# GE Nuclear Energy

EIS IDENT: SHROUD STABILIZER HARDWARE

FMF: PEACH BOTTOM 2 AND 3

**GE RESPONSES  
TO NRC QUESTIONS  
FOR  
PEACH BOTTOM SHROUD REPAIR**

Figure 1. Peach Bottom Shroud / Stabilizer ASIST Model Definition

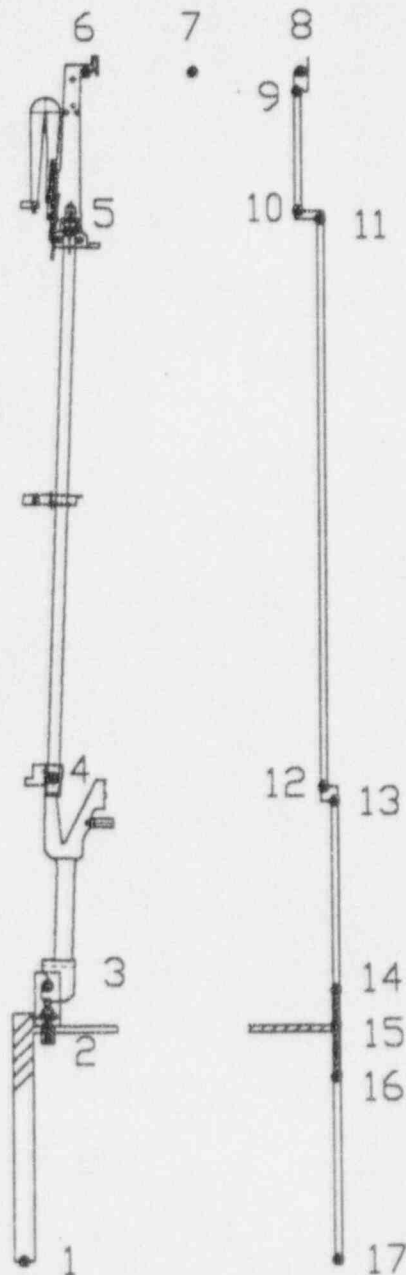
This section presents a description of the analytical model and the inputs to the model which produce the axial load distributions in the stabilizer assemblies and shroud for the cases of normal operation with normal temperature and pressures and the case of a thermal transient with the corresponding temperature and pressures. The model is schematically shown in Figure 1. The model consists of a system of collinear two-dimensional beams, each beam representing the length and stiffness of a major component of the stabilizer assembly and shroud. Direct inputs to the beam elements of Modulus of Elasticity, coefficient of thermal expansion, temperature, distributed axial loading and point loads appropriately addressed the effects of component stiffness, temperature differences, pressure differences, component weights and mechanical preload of the tie rods. The ASIST computer program was used to solve the system of beam elements and produce the resulting load distributions.

Figure 2. Peach Bottom Shroud / Stabilizer  
ASIST Model Axial Stiffness Values

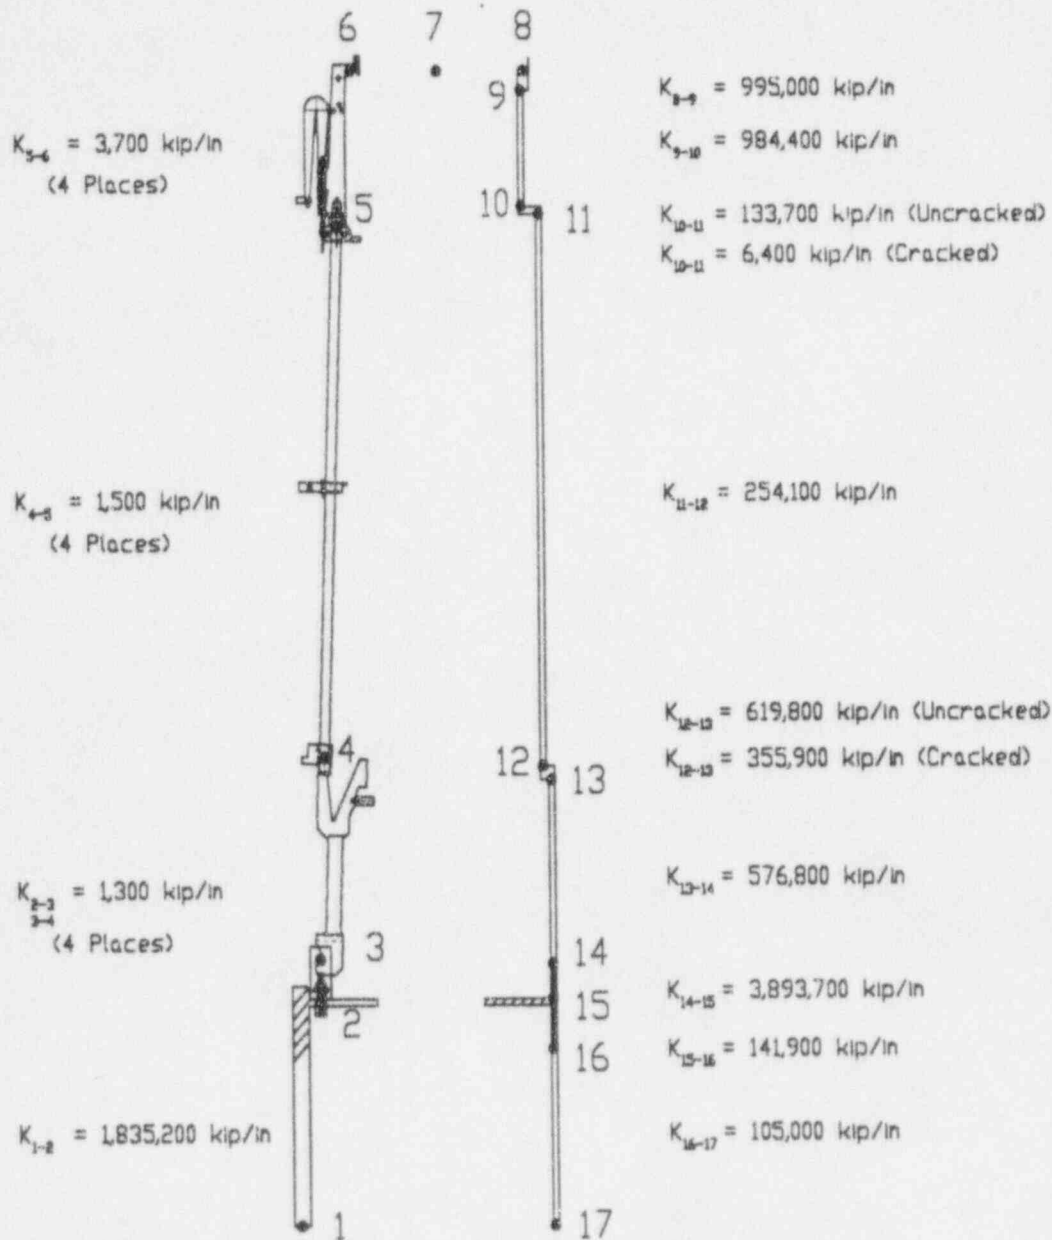
The axial stiffness of the lower stabilizer spring assembly and the upper support assembly were determined by finite element analysis. The tie rod axial stiffness was determined by a simple hand calculation of a beam in tension. The values used are shown in Figure 2.

The axial stiffness of the shroud was determined by a combination of finite element analysis and theoretical ring stiffness calculations. The axial stiffness of the shroud shell members, shroud support ring and struts were determined by finite element analysis. The resulting axial stiffnesses are shown in Figure 2.

The axial stiffness of the shroud shell to ring welded connection was determined using the method of analysis and equations from Section III, ASME B&PV Code, 1965 Edition, Appendix I, Article 1-2. This method was used for the ring axial stiffness between welds H2-H3 and H5-H6. The stiffness was determined for both the case of intact welds and fully cracked welds. The fully cracked welds were assumed to be through wall at the top of the weld fillet as schematically shown in Figure 3. Values of the axial stiffnesses used for the cracked and uncracked condition are shown in Figure 2.
